**Springville City
BARTHOLOMEW WATER TANK
Contract Documents**

ADDENDUM #02

June 07, 2018

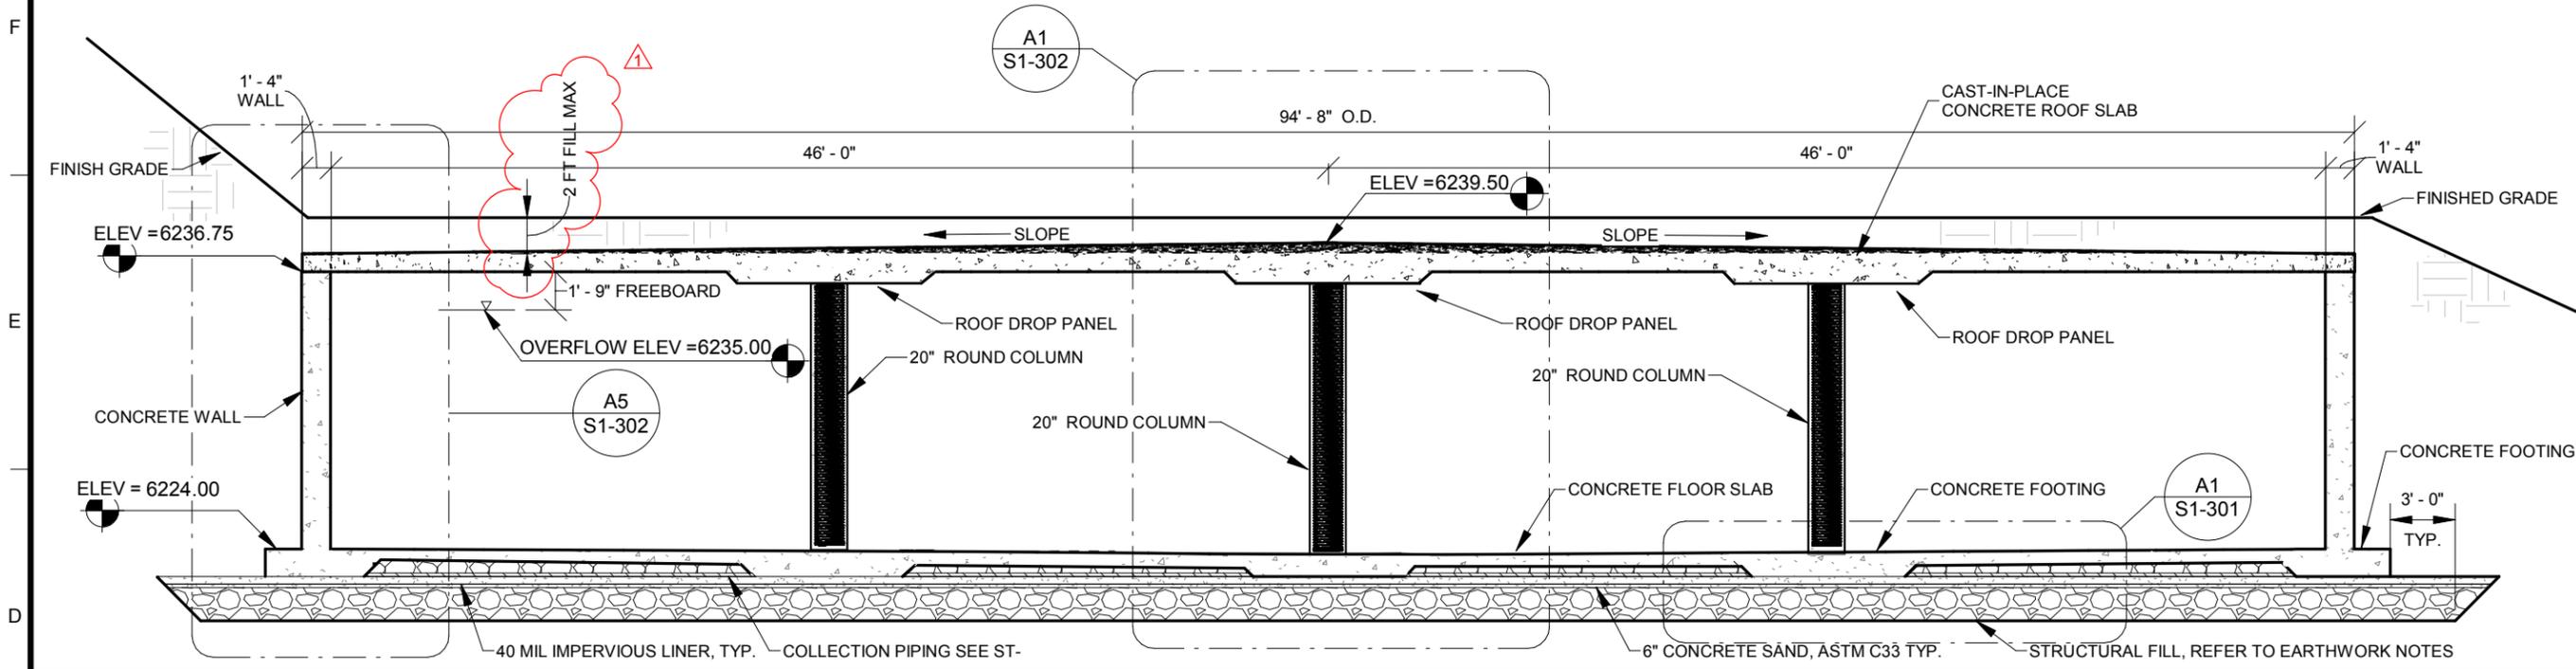
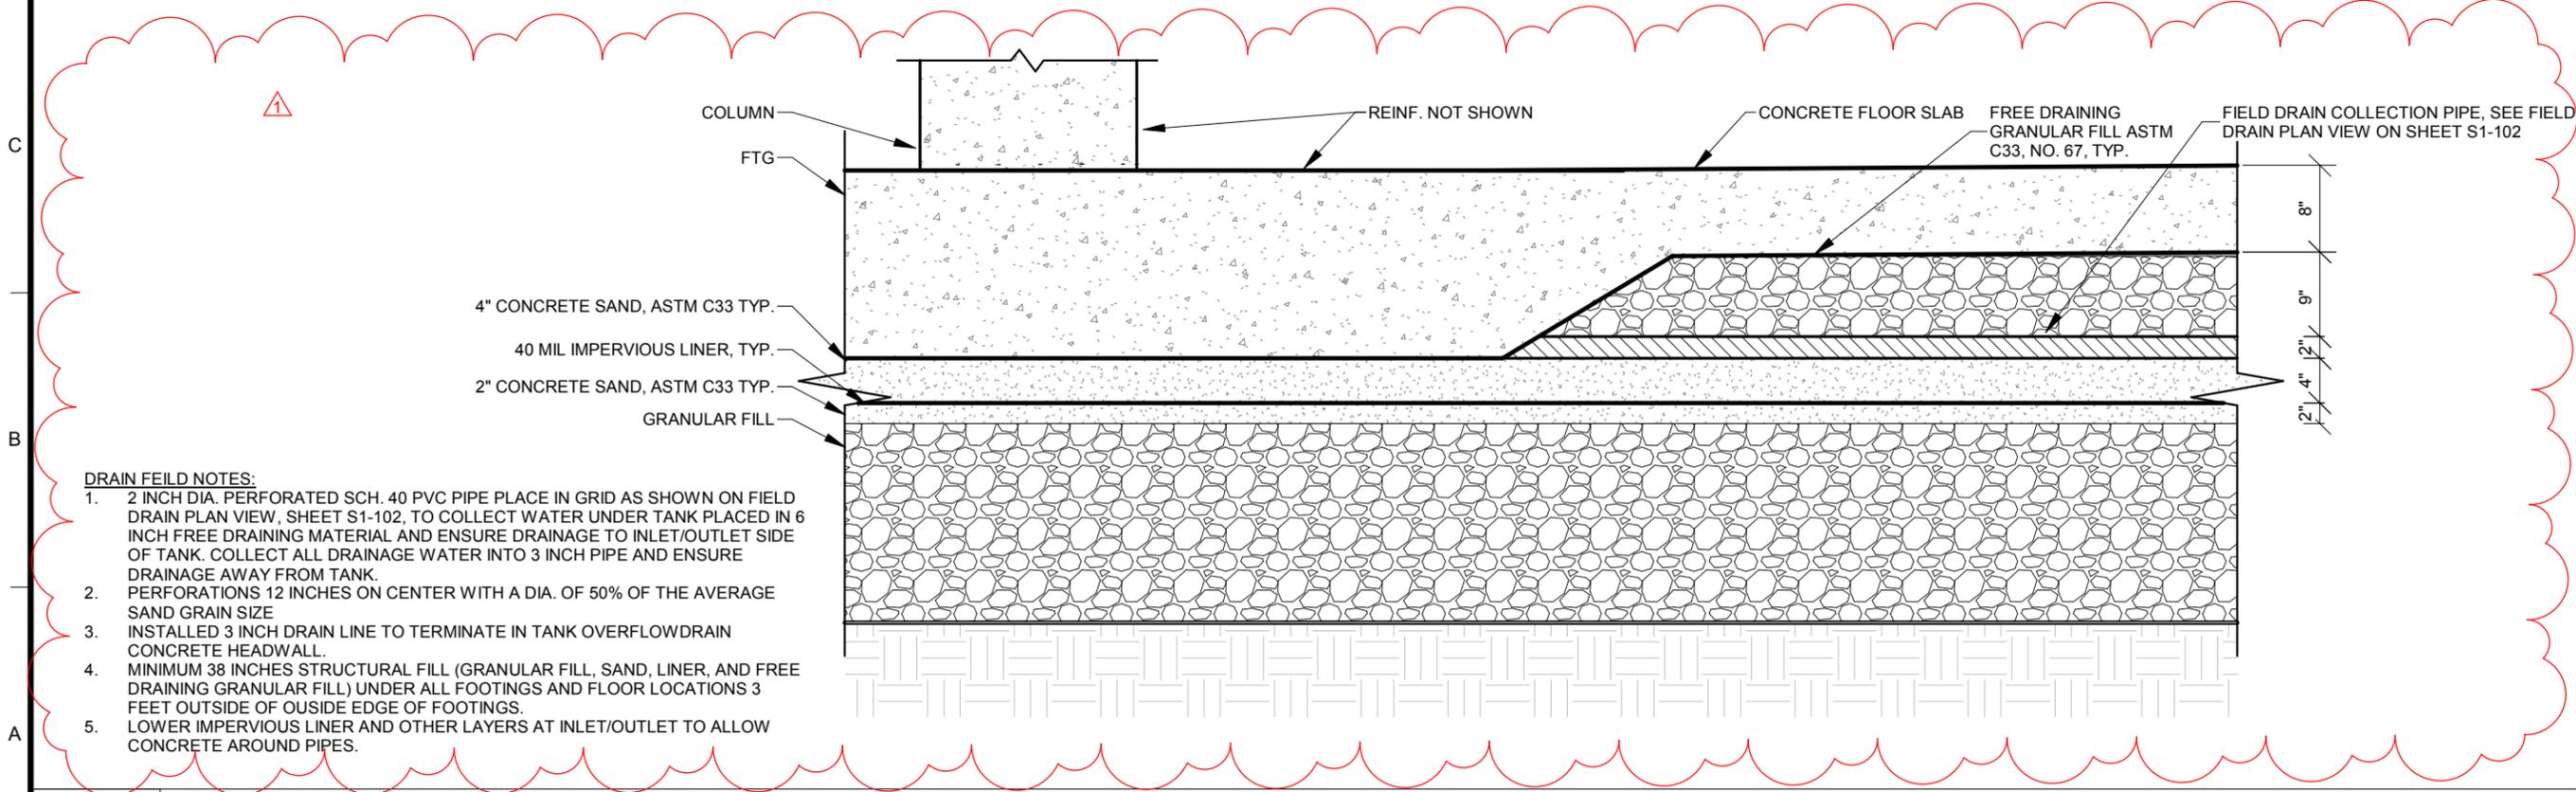
- a. Replace/Add drawing S1-102, S1-103, S1-301, S1-502, S1-601, S2-101, S2-202 and S2-502 with revision 1 drawings. Revisions include:
 - 1. Addition of Tank Foundation Drain Field with cross section, clarity of roof slab thickness, increased curb height for access hatch, revised access hatch type and additional detail on the weir box hatch.

- DRAIN FEILD NOTES:**
1. 2 INCH DIA. PERFORATED SCH. 40 PVC PIPE PLACE IN GRID AS SHOWN ON FIELD DRAIN PLAN VIEW, SHEET S1-102, TO COLLECT WATER UNDER TANK PLACED IN 6 INCH FREE DRAINING MATERIAL AND ENSURE DRAINAGE TO INLET/OUTLET SIDE OF TANK. COLLECT ALL DRAINAGE WATER INTO 3 INCH PIPE AND ENSURE DRAINAGE AWAY FROM TANK.
 2. PERFORATIONS 12 INCHES ON CENTER WITH A DIA. OF 50% OF THE AVERAGE SAND GRAIN SIZE
 3. INSTALLED 3 INCH DRAIN LINE TO TERMINATE IN TANK OVERFLOW DRAIN CONCRETE HEADWALL.
 4. MINIMUM 38 INCHES STRUCTURAL FILL (GRANULAR FILL, SAND, LINER, AND FREE DRAINING GRANULAR FILL) UNDER ALL FOOTINGS AND FLOOR LOCATIONS 3 FEET OUTSIDE OF OUSIDE EDGE OF FOOTINGS.
 5. LOWER IMPERVIOUS LINER AND OTHER LAYERS AT INLET/OUTLET TO ALLOW CONCRETE AROUND PIPES.
